Access Compliance Report Public Rights-of-Way (Curb Ramps)

Main Street: BRITTANY_WOODS_DR Cross Street: RAINBOW_DR Location: W

ADA ID: RPRK211014153047 Ramp Type: Type 4 - Parallel Initial Pass/Fail: Pass Overall Compliance: No Severity Score: 26

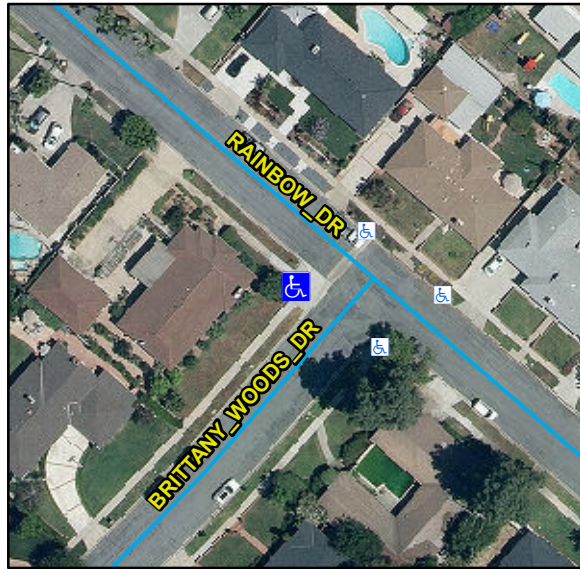
Compliance	Description	Data	Compliance	Description	Data
N/A	Ramp Length LT (in)	150	N/A	Ramp Length RT (in)	152
Yes	Ramp Width LT (in)	96	Yes	Ramp Width RT (in)	94
Yes	Ramp Run Slope LT (%)	4.5	Yes	Ramp Run Slope RT (%)	7.1
Yes	Ramp Cross Slope LT (%)	2	Yes	Ramp Cross Slope RT (%)	1.5
N/A	Landing Present	No	No	DWS Provided	No
N/A	Landing Length (in)	N/A	N/A	DWS Contrast	N/A
No	Landing Width (in)	N/A	N/A	DWS Length (in)	N/A
No	Landing Run Slope (%)	N/A	N/A	DWS Full Width	N/A
No	Landing Cross Slope (%)	N/A		DWS Offset Type	N/A
N/A	Landing Movement Obstructed?	No	N/A	DWS Offset Left (in)	N/A
	Landing Movement Type	Curb	N/A	DWS Offset Right (in)	N/A
N/A	Landing Shared	N/A			
N/A	Clear Space	Yes			
N/A	Clear Space To Crosswalk (in)	48			
N/A	Marked Crosswalk 1	No	N/A	Marked Crosswalk 2	No
	Crossing 1 Direction	SE		Crossing 2 Direction	NE
N/A	Marked Crosswalk 1 Width (in)	N/A		Marked Crosswalk 2 Width (in)	N/A
N/A	Ramp Inside Crosswalk 1	N/A	N/A	Ramp Inside Crosswalk 2	N/A

Crossing 1 Slope (%)	6.9		Crossing 2 Slope (%)	3.6
	Crossing 1 Cross Slope (%)	1		Crossing 2 Cross Slope (%)	0.9
Yes	Gutter Ponding	No	No	Curb Slope	8.8
Yes	Gutter Lip Height (in)	0		Road Run Slope (%)	0.1
No	Gutter Run Slope (%)	8.3		Road Cross Slope (%)	1.7
Yes	Gutter Cross Slope (%)	1.3	No	Perpendicular Joint Present	No
Yes	Overall Surface Condition	Acceptable			
	Cross Gutter Present?	Yes		Spandrel Present?	Yes
	Replace Cross Gutter?	No		Replace Spandrel?	No

Remove & Replace Curb Ramp With Two New Directional Ramps or Equivalent. Remove & Replace Gutter.
